8th & HOWELL

DESIGN RECOMMENDATION SUBMITTAL 2: 9.16.2014

DPD Project #: 3016917

8th Avenue Minimum Façade Height

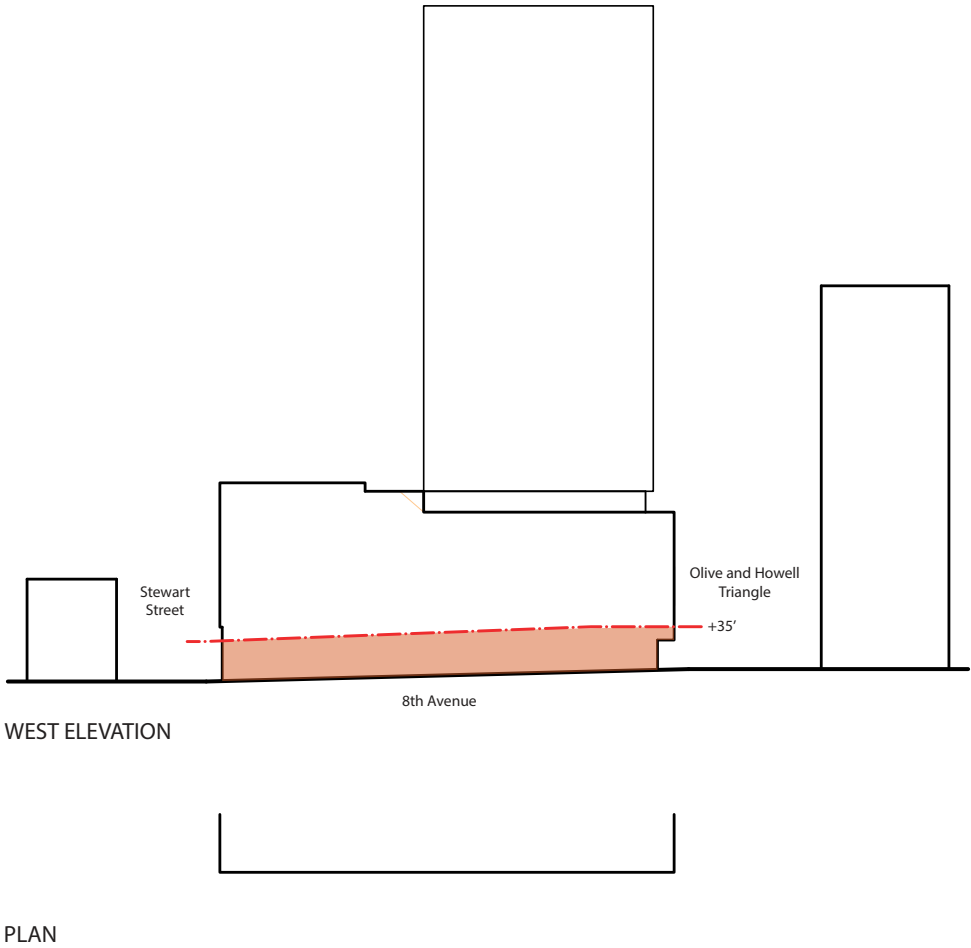
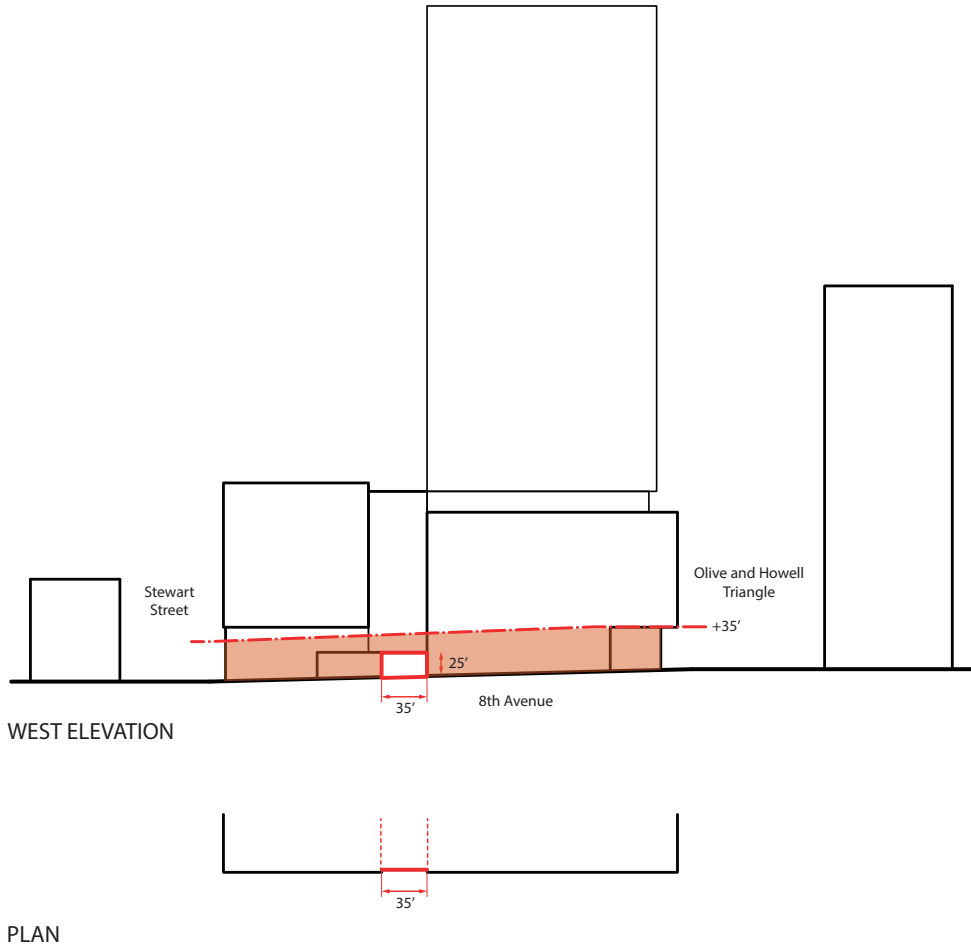
ITEM #	DEVELOPMENT STANDARD	REQUIREMENT	RATIONALE	DOWNTOWN DESIGN GUIDELINES REINFORCED
6	23.49.056.A Street Façade Height	8th Avenue is a designated Class 1 pedestrian street and requires a minimum continuous facade height of 35 feet.	The proposed scheme incorporates a service drive to access parking garage and loading dock entries away from the street façade rather than having them directly facing 8th Avenue. The height of the service drive however does not comply with the technical requirements for the continuity of façade height along 8th Avenue. The design proposal supports the intent of the code requirement by enhancing the pedestrian experience with a glazed façade returning into the service drive and an improved access connection. By adding the service drive entrance at 8th Avenue, we allow service traffic to turn and be managed within the site which improves the traffic connections and flow into the complicated one-way system around the block.	A-1 Respond to the physical environment B-1 Respond to the neighborhood context B-3 Reinforce the positive urban form & architectural attributes of the immediate area C-1 Promote pedestrian interaction C-3 Provide active-not blank-facades C-4 Reinforce building entries E-2 Integrate parking facilities E-3 Minimize the presence of service areas

Maximum Setback at Intersections

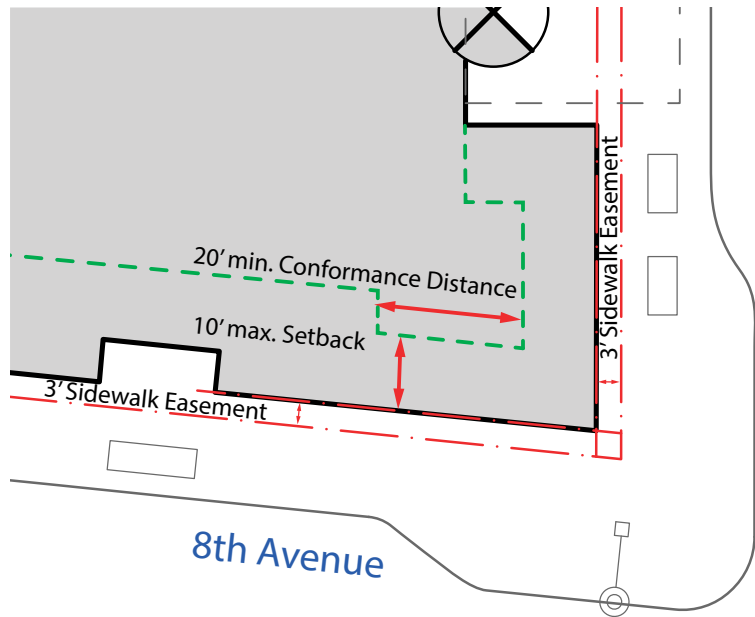
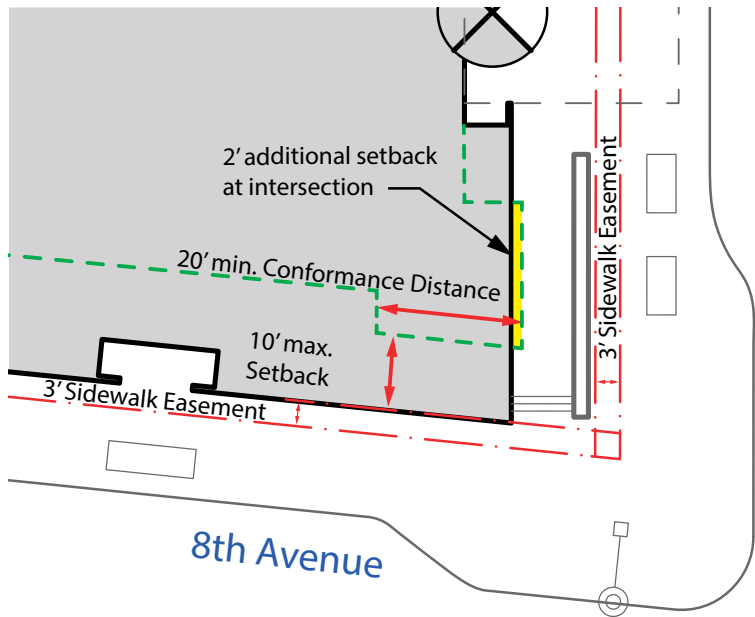
ITEM #	DEVELOPMENT STANDARD	REQUIREMENT	RATIONALE	DOWNTOWN DESIGN GUIDELINES REINFORCED
7	23.49.056.B.2.d Maximum facade set-back at intersections	<p>The maximum setback of the facade from street lot lines at intersections is 10 feet. The minimum distance the facade must conform to this limit is 20 feet along each street.</p> <p>If a sidewalk is widened into the lot as a condition to development, setback standards shall be measured to the line established by the new sidewalk width rather than the street property line.</p>	<p>The proposed scheme articulates the building corners at street level with simple volumetric moves to clearly define building entries and add visual character within the larger building massing. This approach, as previously presented and confirmed to DRB, requires the following departure at the intersection of Howell Street at 8th Ave.</p> <p>At Howell Street the entire building façade is setback at street level as part of the overall building massing. This singular setback is at 12' from the Howell lot line which is 2' larger than the 10' maximum. At 8th Avenue this setback ensures a continuous and consistent architectural expression in support of the downtown design guidelines.</p>	<p>B-1 Respond to the neighborhood context</p> <p>B-2 Create a transition in bulk and scale</p> <p>B-3 Reinforce the positive urban form & architectural attributes of the immediate area</p> <p>B-4 Design a well-proportioned and unified building</p> <p>C-1 Promote pedestrian interaction</p> <p>C-2 Design Facades of many scales</p> <p>C-4 Reinforce building entries</p> <p>D-1 Provide inviting and useable open space</p> <p>D-3 Provide elements that define the place</p>
